GC0104 DRAFT EUROPEAN CONNECTION CONDITIONS LEGAL TEXT

DATED 0547/034/18

**EUROPEAN CONNECTION CONDITIONS
(ECC)**

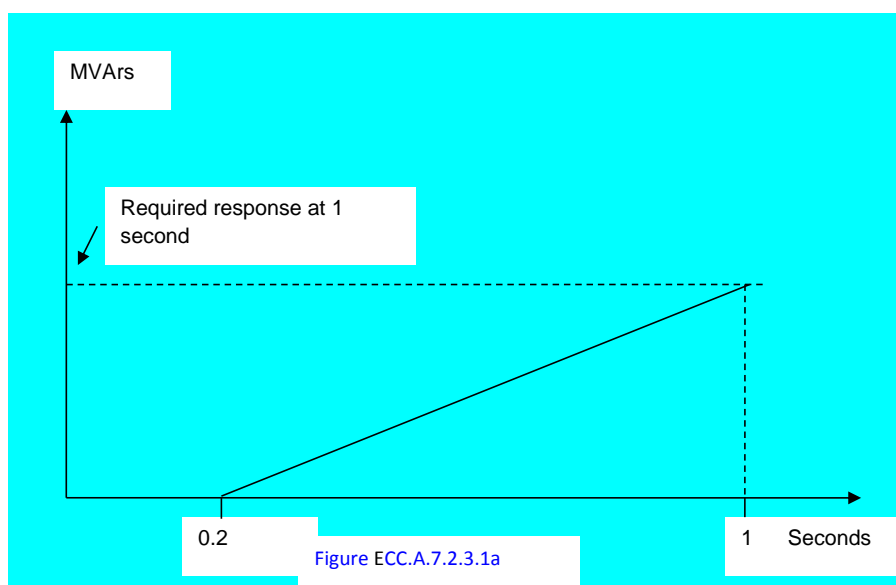
Comment [A18]: This diagram needs updating to include interface Point and HVDC Interface Point Voltage
